NO: MS-023 **PRODUCT:** ZG2-WDC Controller Unit
DATE: December 2015 **TYPE:** Modification Notice

ZG2-WDC Profiling Sensor Controller Unit will be Modified with a Larger LED Display for Improved Visibility

Effective date: May 2016 production

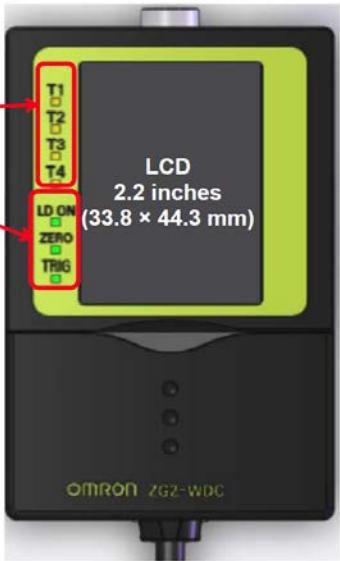
Reason for Modification: The original LCD screen manufacturer discontinued the part. Omron took the opportunity to find a larger screen to improve visibility and consolidated the indicators along the left side of the display.

Before the change	After the change
The LCD size 1.8 inches	The LCD size 2.2 inches
The location of indication LEDs T1, T2, T3, T4, LD ON, ZERO, TRIG	The location of indication LEDs T1, T2, T3, T4, LD ON, ZERO, TRIG
